BCA Capability Statement

Project: 105 Miller Street North Sydney
Education Scheme

16 April 2025

Reference: 240167

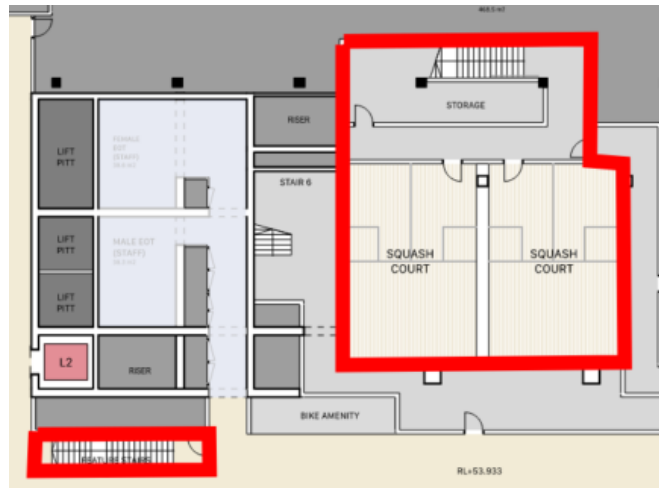
Comment: The lower levels (Lower Ground Level – Level 4) are connected by a series of escalators which creates a fire compartment that exceeds the maximum permitted. Accordingly, fire compartment drawings are to be provided prior to the Construction Certificate stage and the excessive compartment size addressed with inclusion within the FER.

Note: The below figures show fire separation on the basement and Lower Ground Level which limits the extent of which floor area is connected.

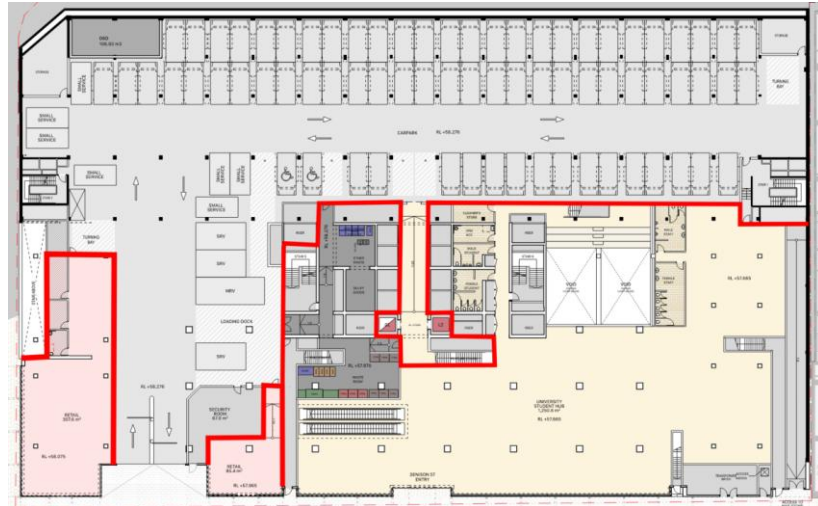
Basement - The level contains Bike Parking (Class 7b), Squash Court (Class 9b), End of Trip Facilities and various plant rooms. In lieu of the whole level assuming the 4-hour FRL associated with the Class 7b bike parking area or introducing a fire wall that achieves an FRL of 240/240/240 to separate the bike parking area from the remainder of the floor a Fire Engineered Performance Solution that rationalises the required FRL down to 2-hours will be pursued.

In order to maintain floor-by-floor fire compartmentation the feature stair and the double height Squash Courts (Class 9b) will be fire separated from the remainder of the level.

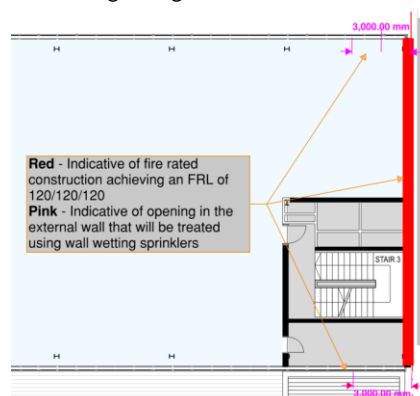
Comment: Portions of the external wall within 3m of the northern boundary are required to achieve a 2-hour FRL and have wall wetting drenchers fitted where the wall incorporates openings (refer to the below figure).

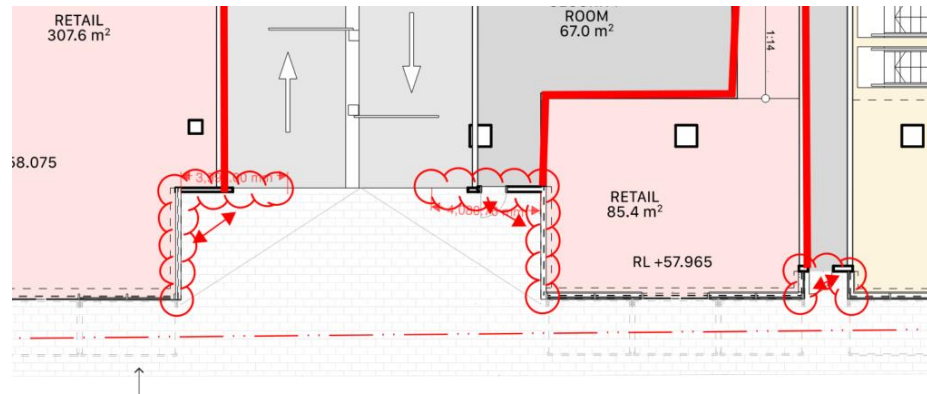
Comment: The line of fire separation described in Clause C3D3 results in portions of the eastern external wall bounding separate fire compartments that are exposed to one another. Accordingly, a Fire Engineered Performance Solution permitting protection to vary from that permitted by BCA Cl. C4D5 will be pursued.

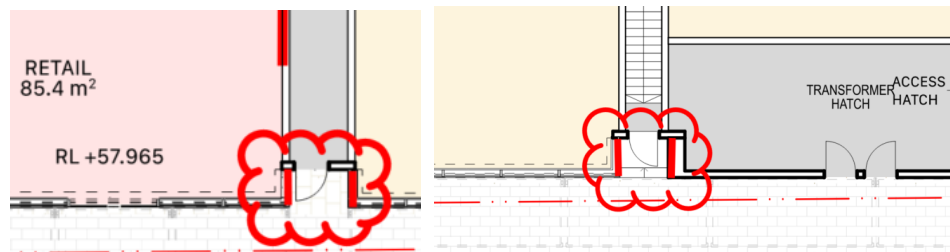
Comment: Occupants discharging the two fire isolated passageways to the eastern frontage on the Lower Ground Level pass within 6m of the external wall which must therefore be fire rated as shown below.

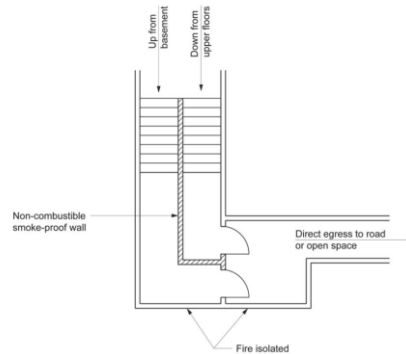
Comment: Escalators indirectly connect the Lower Ground Level to Level 4 which exceeds the maximum 3 levels permitted within a sprinkler protected Class 9b building. Accordingly a Fire Engineered Performance Solution will be developed at the Construction Certificate stage.

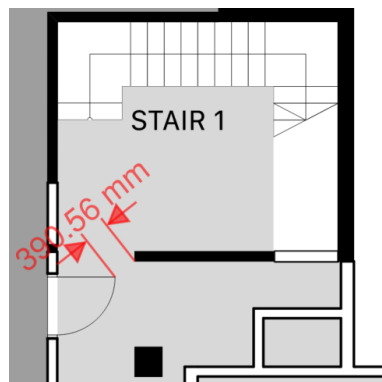
Comment: The goings and risers of the existing heritage stair are inconsistent and due to the heritage constraints it is proposed to pursue a Performance Solution to allow the current arrangement to remain.
